ADDENDUM NO. 2

To: All Planholders
From: Antonio L. Reyna, PE
Subject: Harlingen Economic Development Corporation
The Park at Roosevelt – EDA Grant Project
Date: September 3, 2024

- I. Replace Plan Sheets 6, 9 and 10 with attached Revised Plan Sheets 6, 9 and 10, Addendum No. 2, dated 9/3/2024.

STATE OF TEXAS
 ANTONIO L. REYNA
 LICENSED PROFESSIONAL ENGINEER
 145245
 9.3.2024

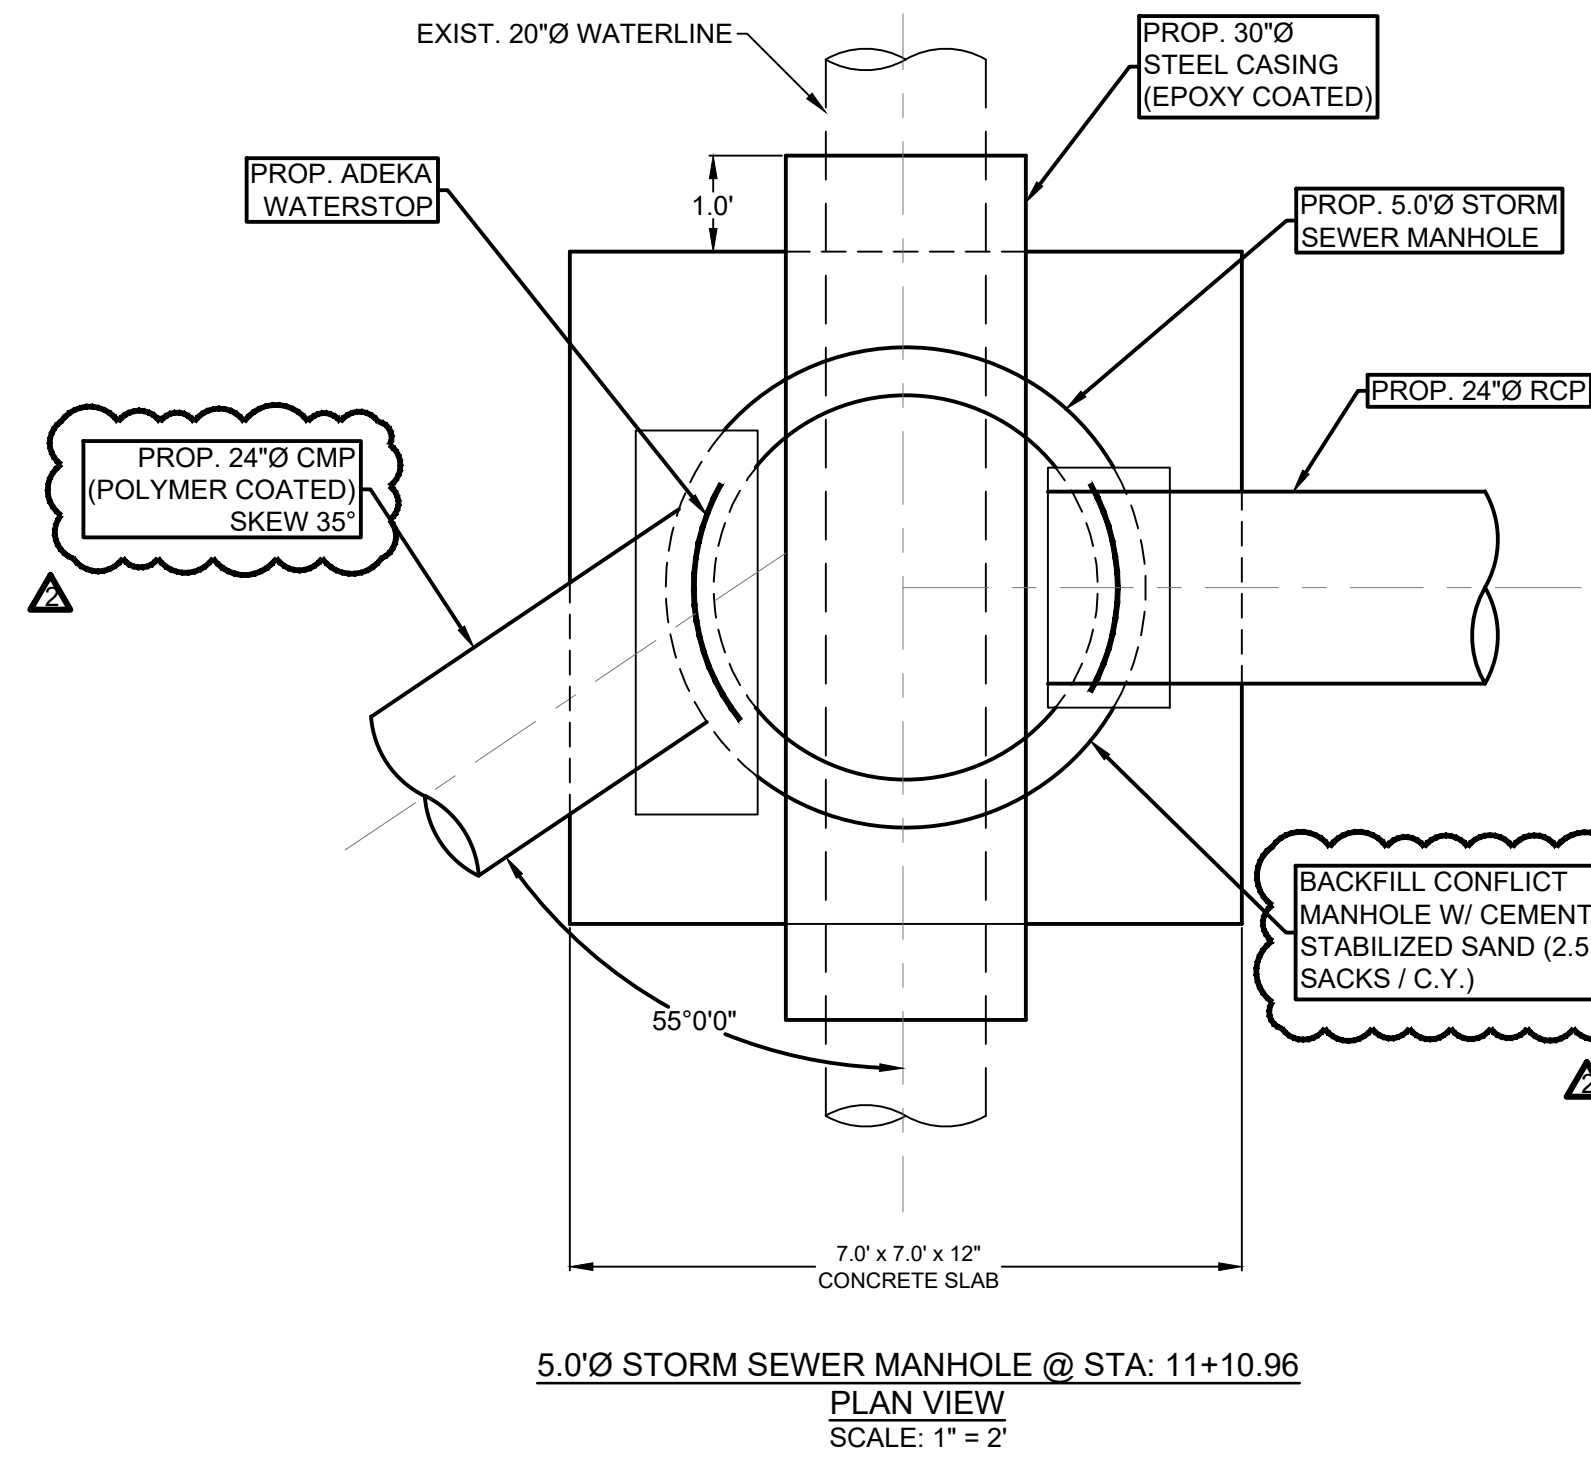
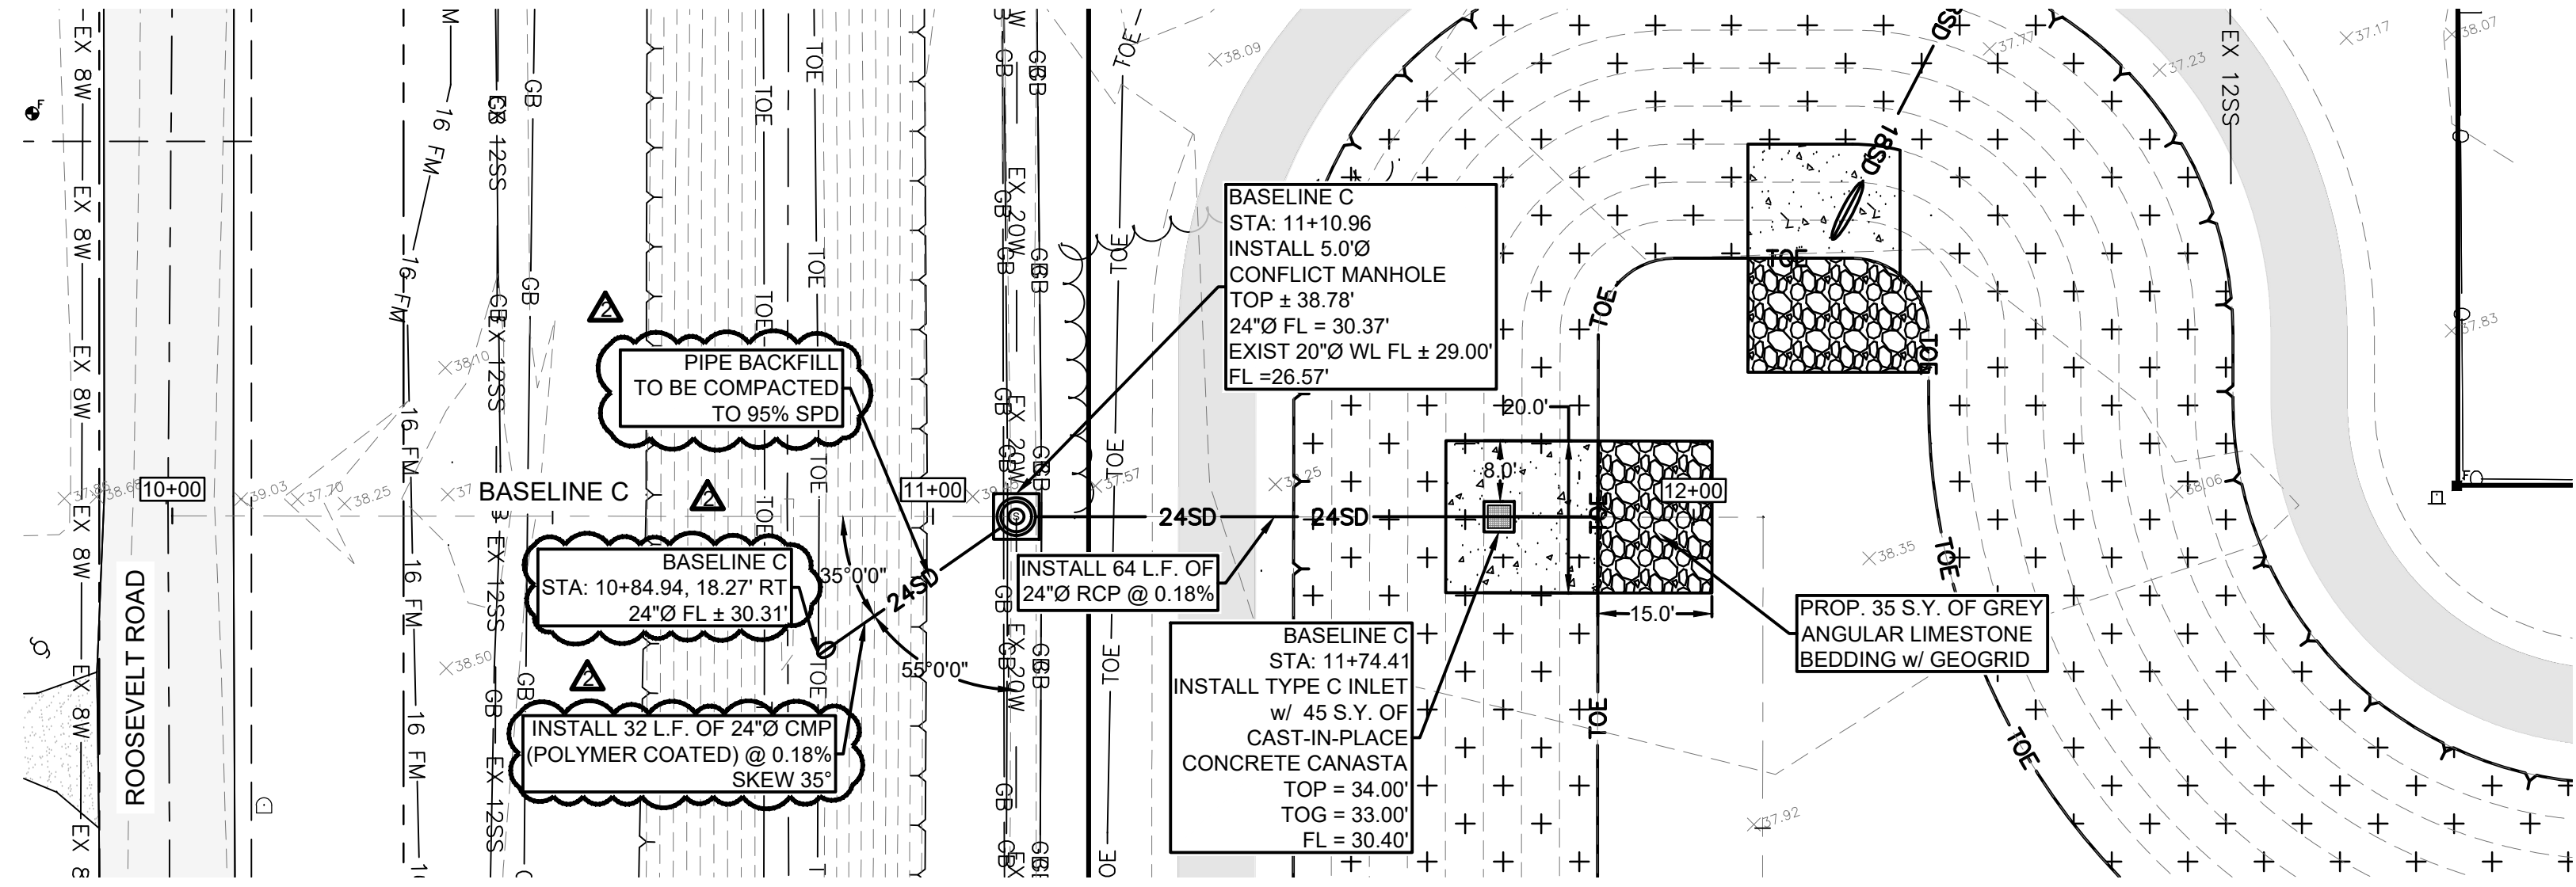
REVISIONS:
 09/03/2024
 ADDENDUM NO. 2
 FIBERMESH TO BE
 1.5 LBS PER C.Y.

CONCRETE SHALL BE CLASS "C" W/ 1.5 LBS PER C.Y. OF FIBER MESH W/ A 3600 P.S.I. MIN. COMPRESSIVE STRENGTH @ 28 DAYS. CURBS SHALL BE BACK FILLED IMMEDIATELY AFTER REMOVAL OF FORMS TO PREVENT TILTING. 2" DUMMY JOINTS @ 10' O.C. MAX.

HARLNGEN ECONOMIC DEVELOPMENT CORPORATION
THE PARK AT ROOSEVELT - EDA GRANT PROJECT
CONSTRUCTION PLANS
STORM SEWER PLAN AND PROFILE
BASELINE C - STA: 10+00 - 13+00

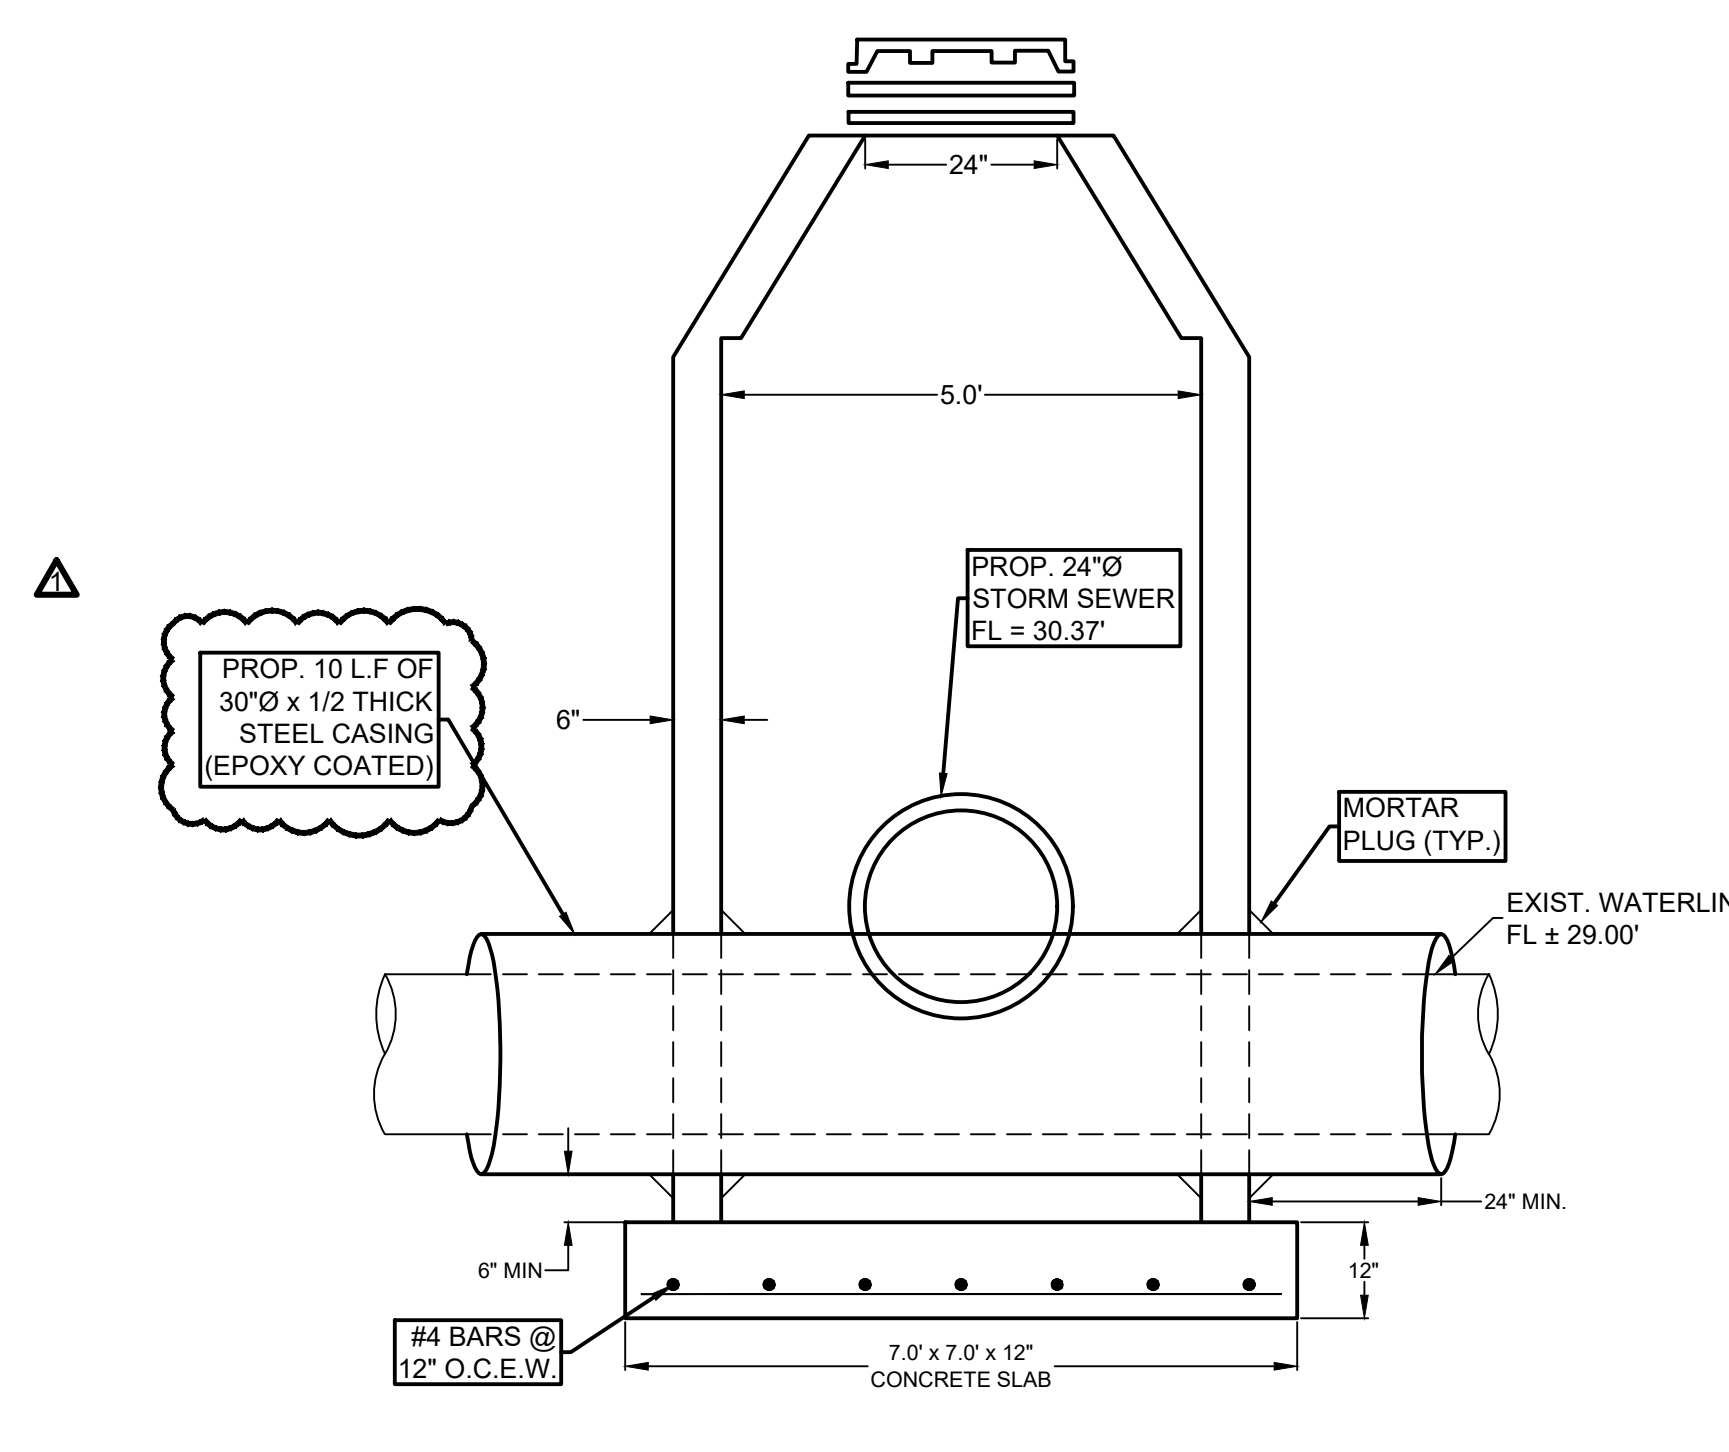
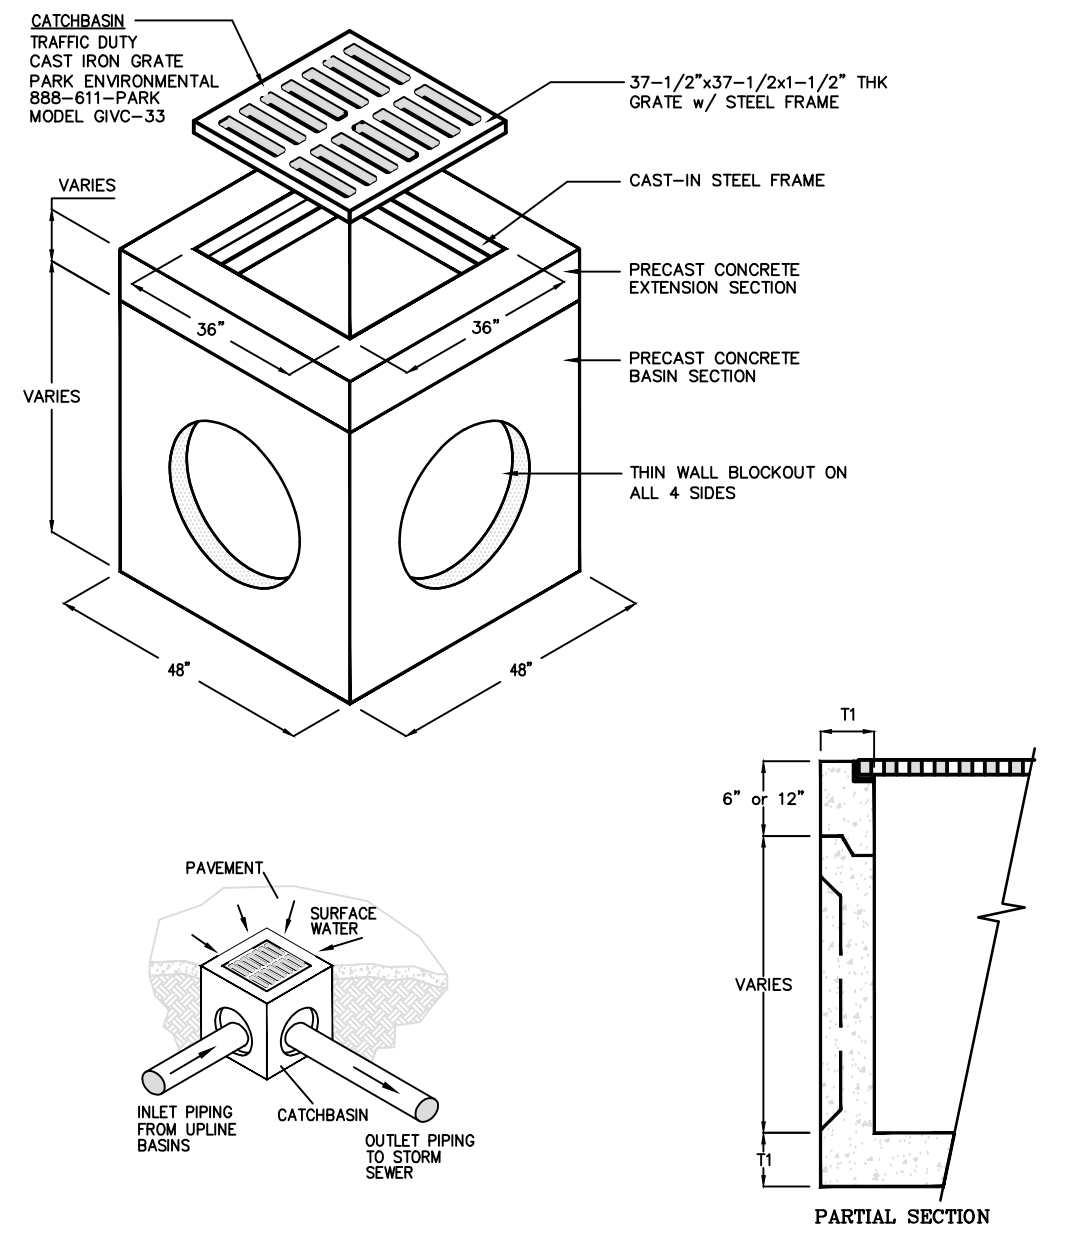
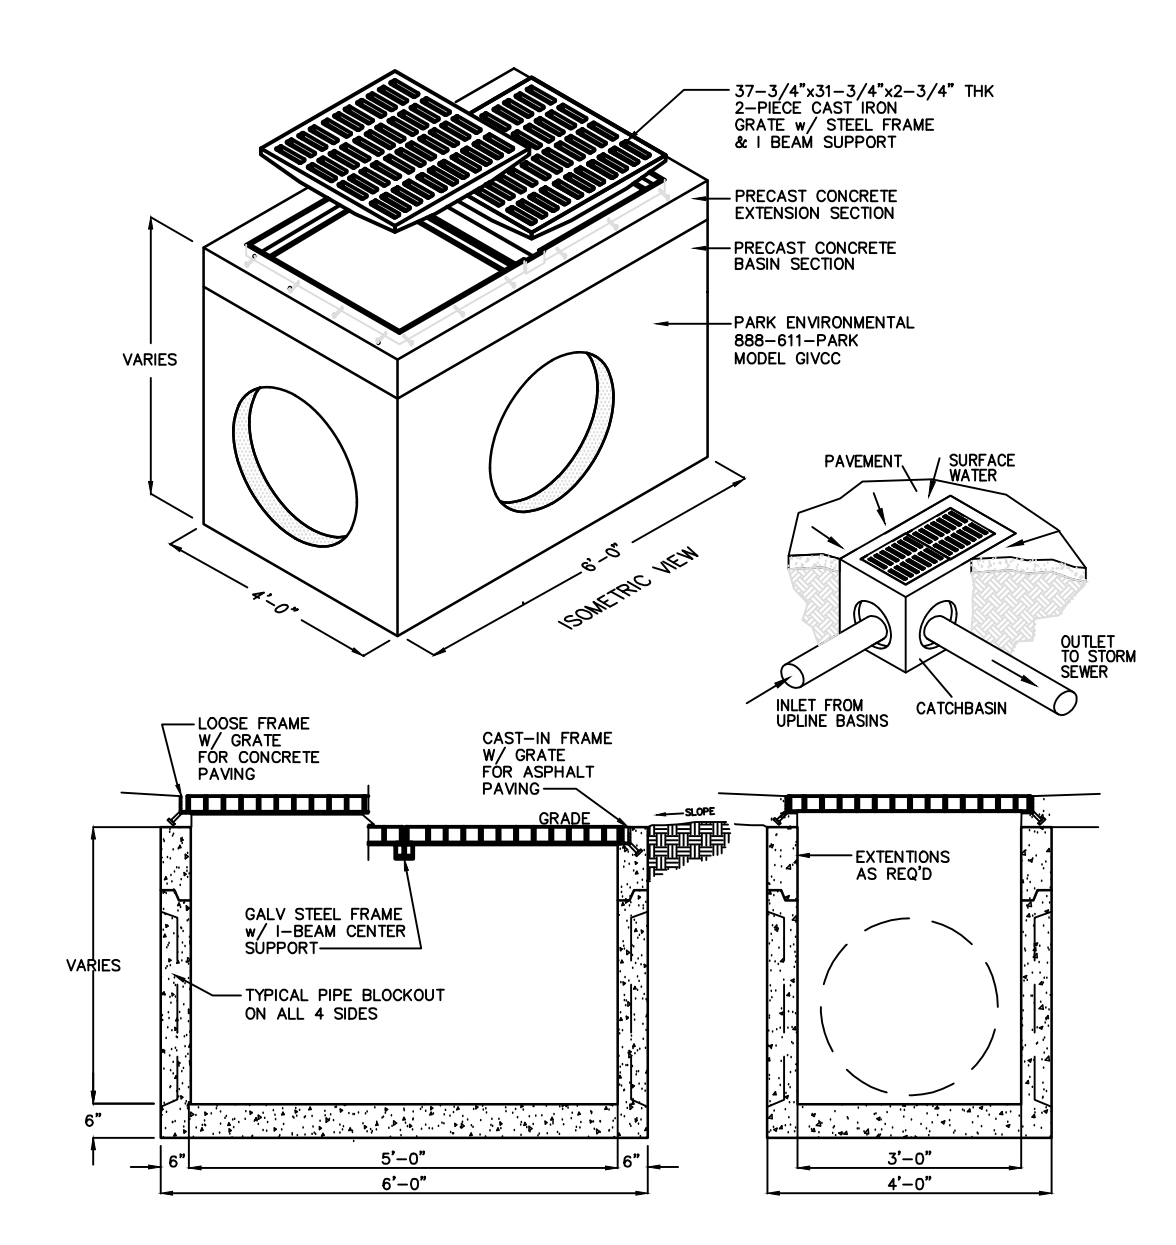
REVISIONS:
08/30/2024
ADDENDUM NO. 1
ADD CASING THICKNESS
09/03/2024
ADDENDUM NO. 2
REMOVED RIPRAP & CMP MOVED 35\"/>

Trench Safety Detail
 Note: Trenches shall be sloped as shown
 Scale: N.T.S.

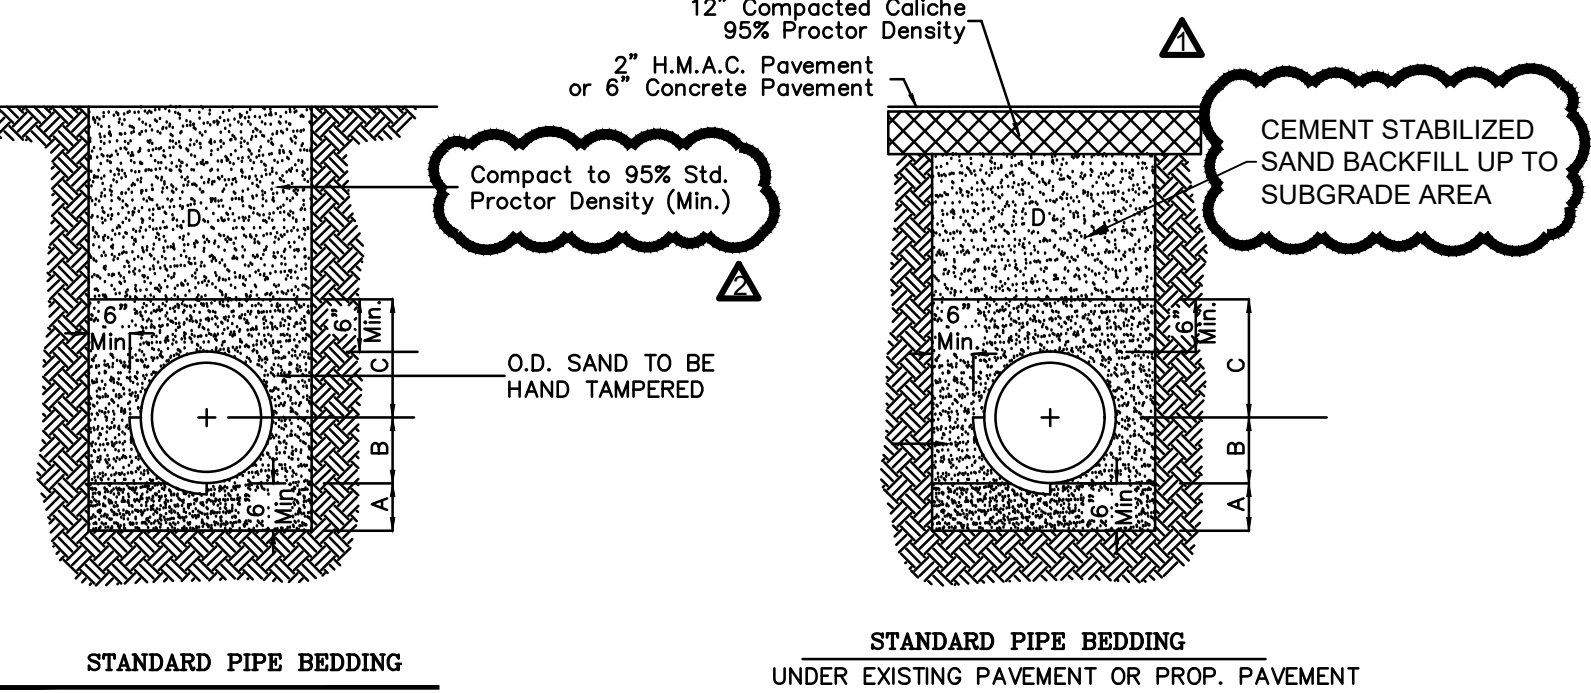
REVISIONS:
 08/30/2024
 ADDENDUM NO. 1
 ADD STABILIZED SAND BACKFILL NOTE
 09/03/2024
 ADDENDUM NO. 2
 BACKFILL SPECIFICATION ADDED.

- A. SAND BEDDING TO BE PLACED BEFORE PIPE IS LAID UP TO FLOW LINE OF PIPE (MIN. THICKNESS = 6")
 - B. SAND BACKFILL PLACED AFTER PIPE IS LAID FROM BOTTOM OF PIPE TO SPRING LINE OF PIPE. (4" LIFTS, CAPS, HAND TAMPED)

- C. SAND BACKFILL PLACED FROM SPRING LINE OF PIPE TO 6" ABOVE TOP OF PIPE. (6" LIFTS, HAND TAMPED)
 - D. FILL TRENCH W/ SELECT BACKFILL, W/ 8" LIFTS COMPACT TO 95% STD. PROCTOR

- FOUNDATION PREPARATION (WELLPOINTS, GRAVEL OR CEMENT STABILIZATION, OR APPROVED SUBSTITUTE) SHALL BE REQUIRED WHEN TRENCH BOTTOM IS UNSTABLE.
- BACKFILLING AT STRUCTURES SHALL BE PLACED IN UNIFORM LAYERS, MOISTENED AS REQUIRED TO APPROXIMATE OPTIMUM MOISTURE CONTENTS AND COMPACTED TO 95% STANDARD PROCTOR DENSITY. THE THICKNESS OF EACH LOOSE LAYER SHALL BE SAND, APPROVED SITE SOIL OR OTHER APPROVED SUBSTITUTE.

- WATER LINE - BACKFILL A,B,D
 SEWER LINE - BACKFILL A,B,C,D
 SAND TO BE ARROYO SAND W/ PI <15
